Friday, 3rd March 2023
[By Post]

RE: RESPONSE TO REQUEST FOR CLARIFICATION OF FURTHER INFORMATION IN RELATION TO PROPOSED DISCOUNT FOODSTORE ANCHORED DEVELOPMENT AT MAIN STREET UPPER, NEWCASTLE, CO. DUBLIN

SOUTH DUBLIN COUNTY COUNCIL REG. REF: SD22A/0312

Figure 1: Revised Site Layout – Magenta outline illustrating RFI Footprint

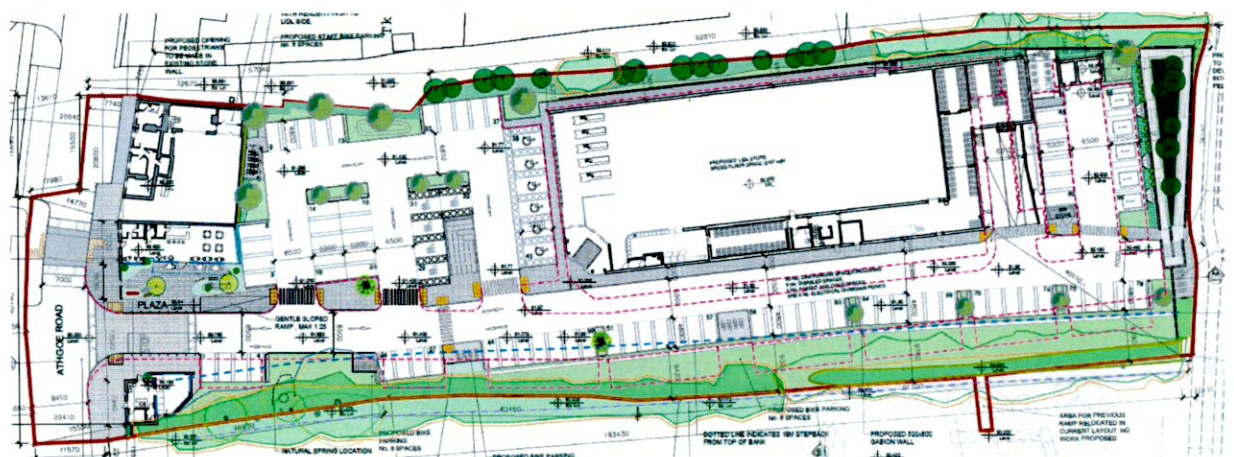
"1. The Planning Authority is not satisfied that the Applicant has interrogated all potential design solutions to provide an appropriate buffer to the adjacent riparian zone from the top of the bank. In this regard the Applicant should provide additional cross sections along the western boundary of the subject site, to facilitate a complete assessment of the relationship between the proposed development and the treatment of the Burgage Plot hedgerow, stream and associated ditch along the entire western boundary. Furthermore, the Applicant should demonstrate the consideration of all potential design solutions which may result in the provision of an appropriate buffer (e.g. undercroft car parking). It is suggested that the Applicant meet representatives from the Drainage and Water Services Department, Parks and Public Realm Department and the Heritage Officer of South Dublin County Council on site to discuss the design approach. Any knock-ons of revisions in relation to other application plans and particulars should be considered."

The roadway has however been reduced in width (from c. 7.5 m to 6.5 m) whilst the remaining principal options related to the building itself which has been adapted accordingly.

The building has been narrowed from c. 33 metres to c. 28 metres, resulting in a cumulative additional area available of c. 6 metres, which has been devoted to the site boundaries. The building has also elongated somewhat as a result, from c. 75.5 to c. 80 metres.

The overall floor area has also reduced, from 2,207 sqm to 2,167 sqm, notwithstanding the provision of a partial first floor (increasing building height from c. 6.74 m to c. 7.02 m), where the overall building footprint has reduced considerably from c. 2,207 sqm to c. 1,920 sqm. The net retail sales area has also been reduced slightly from c. 1,440 to c. 1,373 sqm.

Figure 7: Western Boundary Section @ CFI Stage

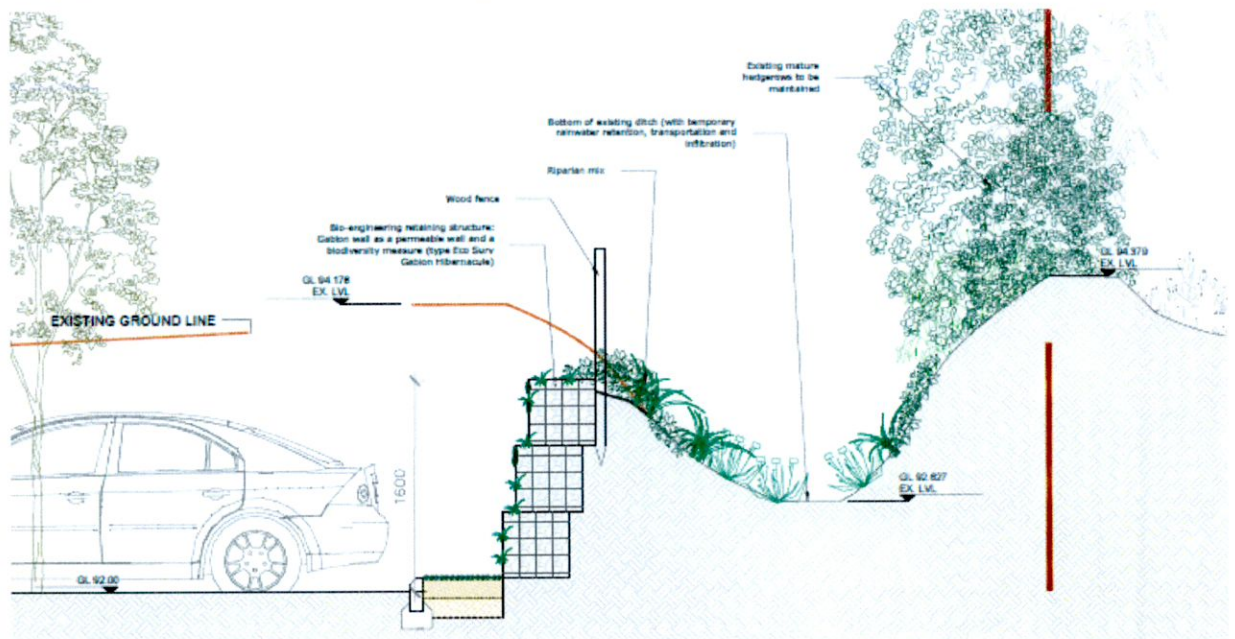
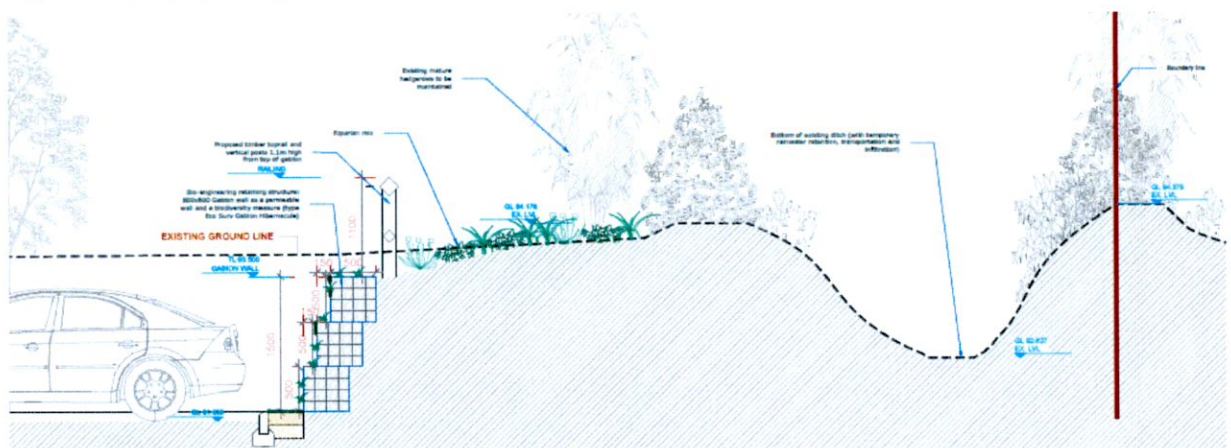
- b) Provide additional cross sections along the western boundary of the subject site, to facilitate a complete assessment of the relationship between the proposed development and the treatment of the Burgage Plot hedgerow, stream and associated ditch along the entire western boundary

In response to this element, we refer to the substantial number of sections and boundary treatment details prepared by both the scheme Architect and Landscape Architect, elaborating on the Burgage Plot hedgerow, stream and associated ditch along the entire western boundary.

Figures 6-7 below illustrate some of the changes arising through Items 1 a) and c) for instance.

Figure 9: Lighting Layout @ CFI Stage

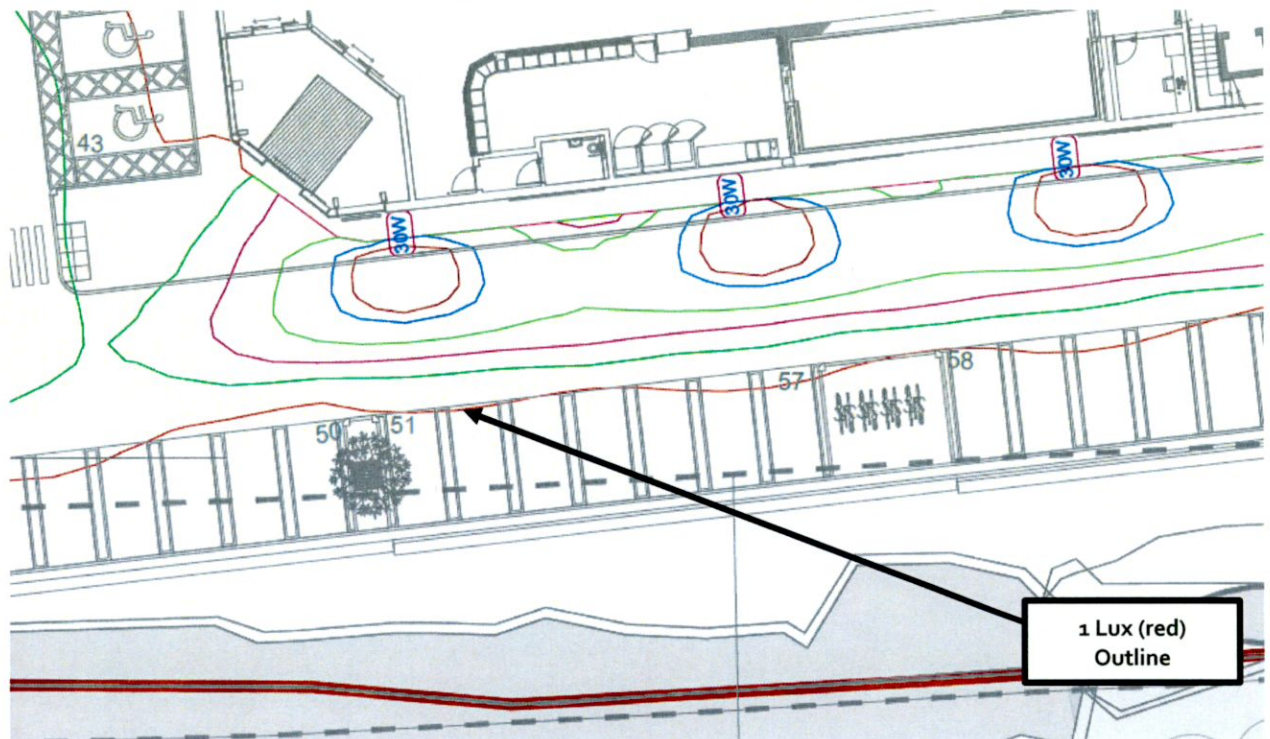
"5. The Applicant is requested to provide a revised lighting layout plan and lighting impact assessment report to address the outstanding concerns regarding the protection of the key ecology corridor along the western boundary of the subject site.

The Applicant should consider the Application of design solutions such as the provision of low level lighting affixed to the gabion walls in this location to protect the integrity of the key ecological corridor in this location.

The revised lighting layout should be assessed by an appropriately qualified bat expert, providing a revised bat survey and assessment of the amended lighting design. Furthermore, the revised lighting design should reflect any amendments applied to the Site Layout Plan as a result of any further design revisions arising from other items of Clarification of Additional Information.

In response to the above, we note that the lighting strategy has been considerably altered, and reduced in scope, to address the concerns of the local Planning Authority.

The extent and type of lighting proposed is now substantially reduced compared to previous proposals, with free standing lighting columns now being largely omitted and replaced with building mounted fixtures (where possible).

The footprint / layout of lighting has also been revised to take account of the other revisions to the site layout, which of themselves result in greater buffering to sensitive boundaries. Figures 8 & 9 below illustrate the RFI and current arrangements, demonstrating the considerable reduction in the lighting footprint on site (noting the 1 lux level for comparison).
